**DOCKET NO: A-98-49  
II-B1-17**

**TECNICAL SUPPORT DOCUMENT FOR SECTION 194.27:  
SANTOS COMPUTER CODE  
IN WIPP PERFORMANCE ASSESSMENT**

**U. S. ENVIRONMENTAL PROTECTION AGENCY  
Office of Radiation and Indoor Air  
Center for the Waste Isolation Pilot Plant  
1310 L St., NW  
Washington, DC 20005**

**March 2005**

Figure 5. Detail of the deformed disposal room with waste for  $f=0$ :  
at 300 years (Figure 5a) and at 10,000 years (Figure 5b)  
(from Stone 1997a, Figures 9 and 10).

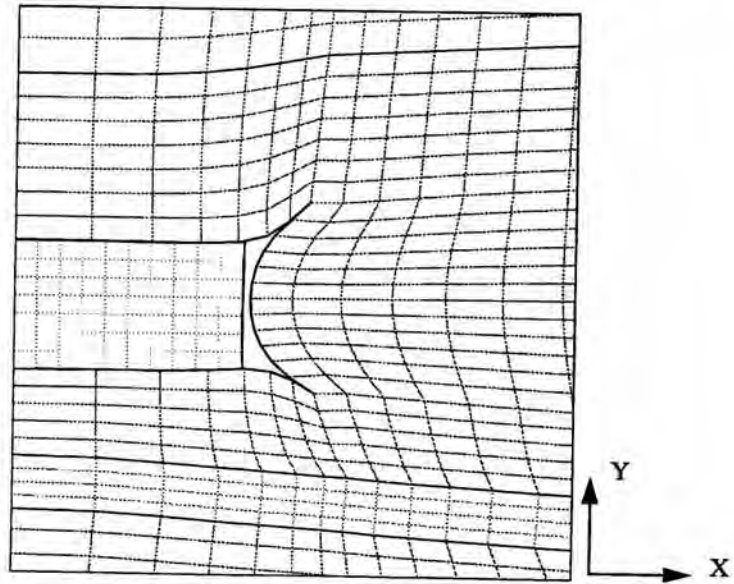
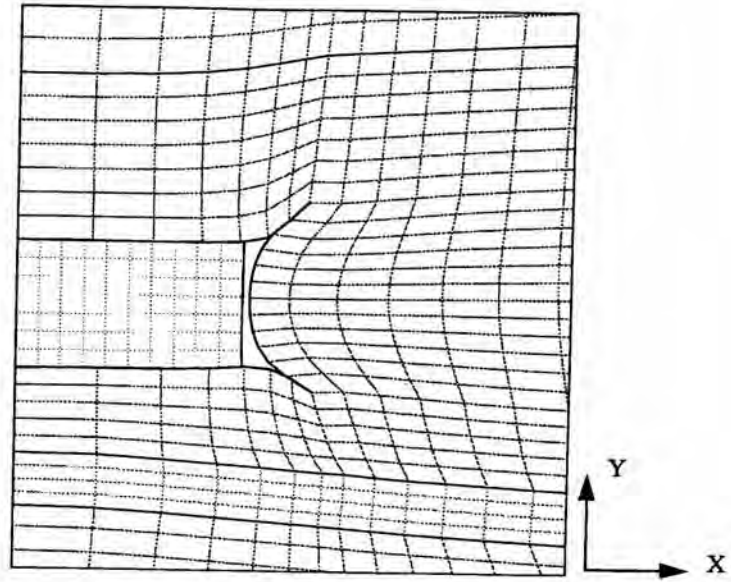
Figures 5a and 5b show the SANTOS-predicted, deformed waste room after 300 and 10,000 years for the case of no gas generation ( $f = 0$ ; Stone 1997a, Figures 9 and 10). As shown in the illustrations, the free space around the waste closes relatively quickly. The waste is essentially fully contacted within 300 years and undergoes relatively little subsequent volume reduction. Figures 6a and 6b show the SANTOS-predicted, deformed waste room after 300 and 10,000 years for gas production at half the reference case rate ( $f = 0.5$ ; Stone 1997a, Figures 11 and 12). Here the gas pressure becomes sufficiently high to allow essentially no further waste volume reduction after 300 years, and to reduce horizontal wall deformation to the point that no significant horizontal back pressure is provided by the waste for 10,000 years. This suggests that waste porosities can remain high and stresses on the waste can remain low when gas is produced in the repository.

EPA's principal accuracy issue with SANTOS is the relatively low mean stress exerted on the waste when no gas is generated, even after 10,000 years when halite creep should have caused the stress to more closely approach a lithostatic state. This low stress has resulted in higher porosities for the waste than would be expected. Several factors, discussed below, are believed to have caused this condition.

Figure 7. Pressure histories for various values of the gas generation parameter  $f$  (from DOE 2004, Appendix PA, Attachment PORSURF, Figure PORSURF-3).

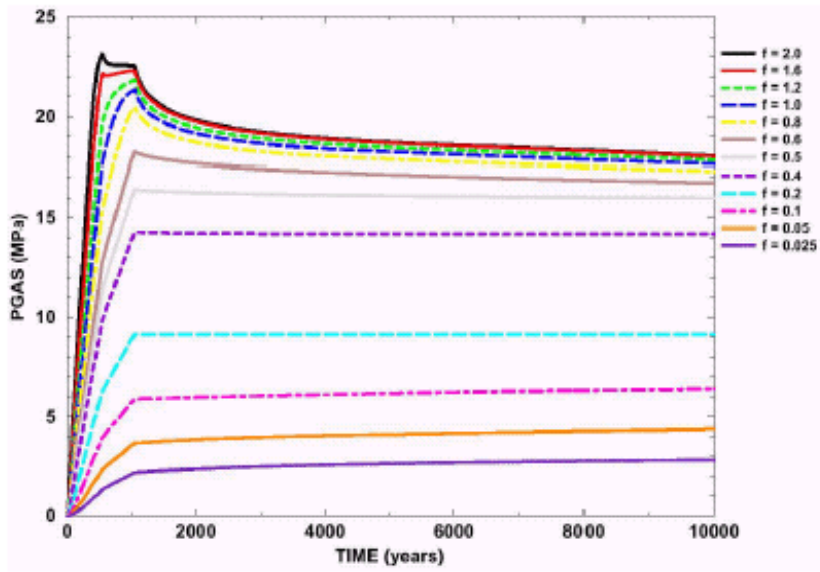
The foregoing conclusion is supported by the results on Figures 7 and 8. For purposes of generating the porosity surface, gas production in SANTOS is assumed to cease after 1,050 years (Stone 1997a, p. 4). Figures 7 and 8 show that for  $f = 0.5$ , after about 1,000 years the waste room gas pressure remains relatively constant at about 16 MPa and the porosity remains approximately constant at about 0.6. This gas pressure is more than sufficient to support the lithostatic pressure of about 15 MPa (F.D. Hansen et al 2003, Section 4.5). Of greater interest is the predicted porosity, shown in Figure 8, of about 0.235 after 10,000 years with no gas production ( $f = 0$ ). Considering the aforementioned initial waste porosity of 0.681, a reduction to 0.235 represents a volume strain of about 0.87. From Figure 1, this strain is equivalent to an average applied pressure of about 4 MPa, which is less than the lithostatic equilibrium pressure of about 15 MPa. This indicates that average stresses on the waste are predicted to remain well below lithostatic after 10,000 years, even with no gas pressure in the room. It is also noted that for the higher gas generation rates, generally for  $f > 0.5$ , the porosity history curves in Figure 8 show an increase in waste room porosity between about 500 and 1,000 years corresponding to room dilation.

The SANTOS model predicts that the waste room will inflate (expand in volume) when the internal gas pressure exceeds the lithostatic stress (Stone 1997a, p. 17). Although waste room dilation is not necessarily interpreted as equivalent to expansion of the waste because waste room porosity is calculated as the ratio of the free room volume to the total room volume, room dilation is accompanied by a calculated increase in room porosity. Waste room dilation is represented in the porosity surface and is carried into WIPP performance assessment through the BRAGFLO code. However, unlike SANTOS, maximum gas pressures in BRAGFLO are limited by escape of gas from the waste room by pressure-induced expansion of existing fractures or creation of new fractures in the anhydrite interbeds (DOE 2004, p. 6-103). As a result, gas pressures in BRAGFLO do not significantly exceed the lithostatic stress of 15 MPa.

Figure 9. WIPP convergence plots for E790 Drift-S2350, Room 3, Panel 2  
 (from TEA 2005; *SANTOS and Porosity Surfaces*, meeting handout by Bill Thompson, Golder Associates)

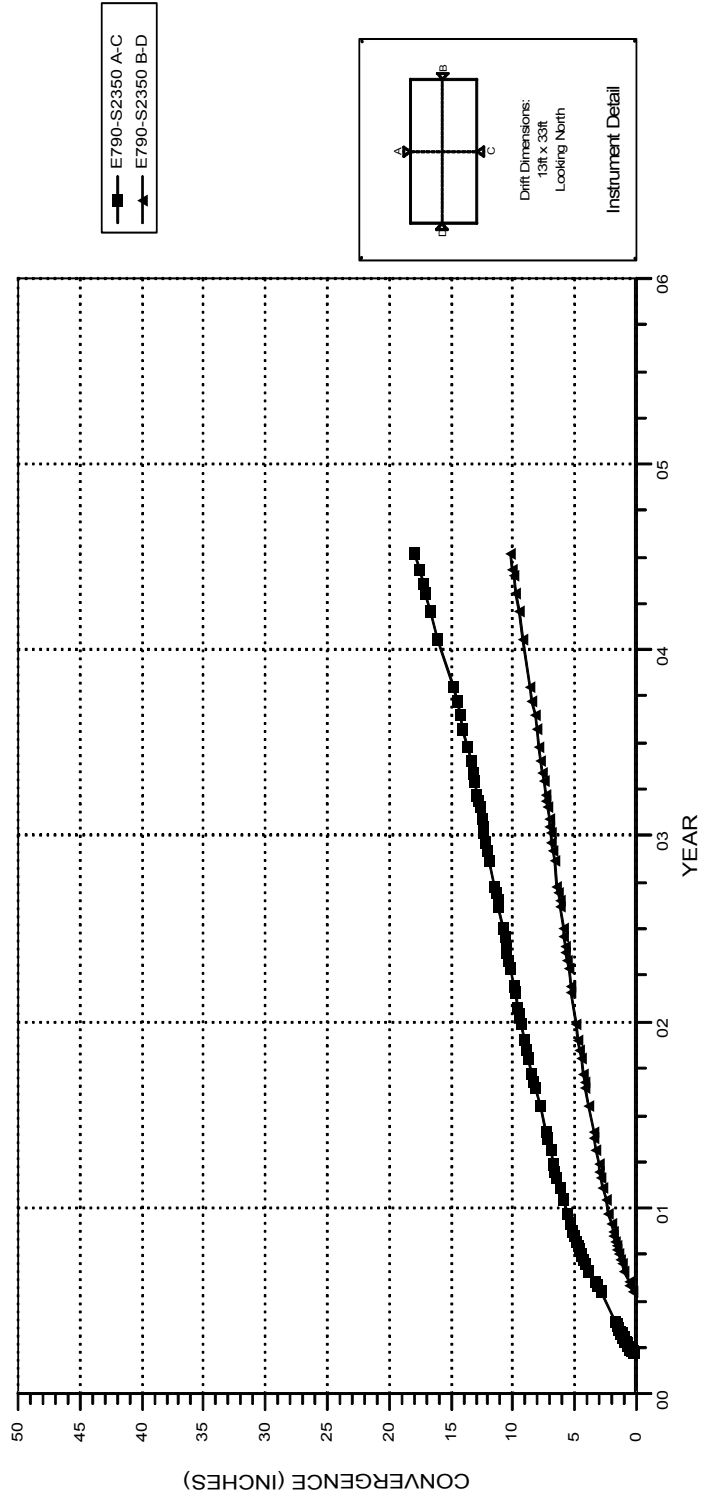
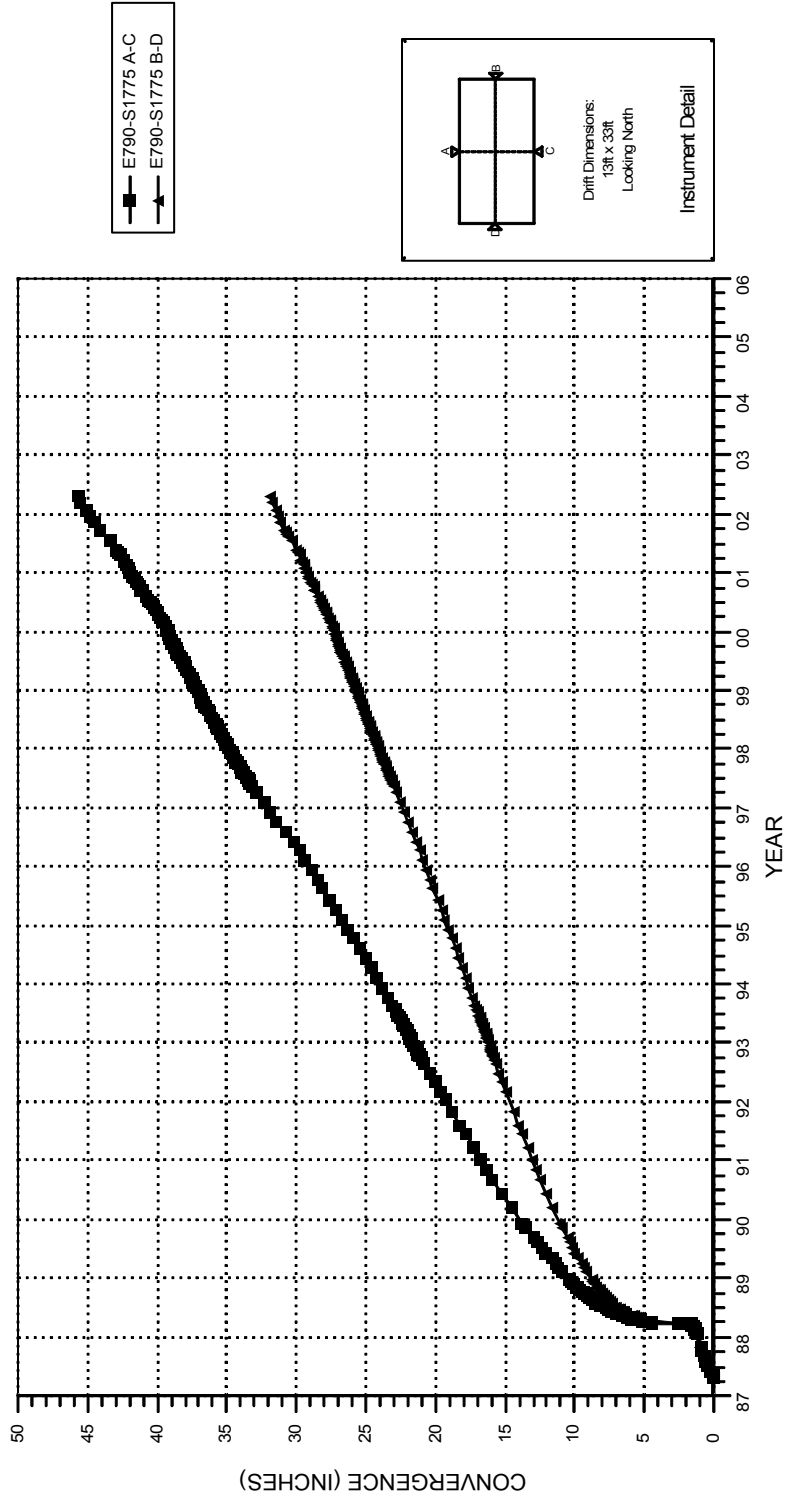
The foregoing considerations suggest that horizontal wall movement into the room would be less rapid than vertical roof and floor movement, even at early times. This expectation has been confirmed by convergence measurements in test drifts at WIPP, as illustrated by Figures 9 and 10 (EPA 2005, *SANTOS and Porosity Surfaces*, meeting handout by Bill Thompson, Golder Associates). The greater span of the roof and floor and the compounding effects of model element contact in the corners of the room provide an adequate qualitative explanation for the SANTOS model prediction of a lower horizontal stress in the walls, however the true magnitude of that stress and the accuracy of the related long-term, secondary halite creep rate after 10,000 years remain uncertain. Although the WIPP field measurements confirm the predicted short-term creep behavior of the halite, they do not address the accuracy of the very slow, long-term rate of return to a lithostatic stress state predicted by SANTOS. The conceptual model of a fairly rapid rate of return to lithostatic equilibrium conditions appears to have been based on recent and historic observations of room closure and halite encapsulation occurring within time frames of tens to hundreds of years and the assumption that the observed closure is accompanied by an equally rapid return to equilibrium stress conditions. However, the room closure observations have not been accompanied by in situ stress measurements and the rate of stress buildup accompanying room closure is therefore uncertain.
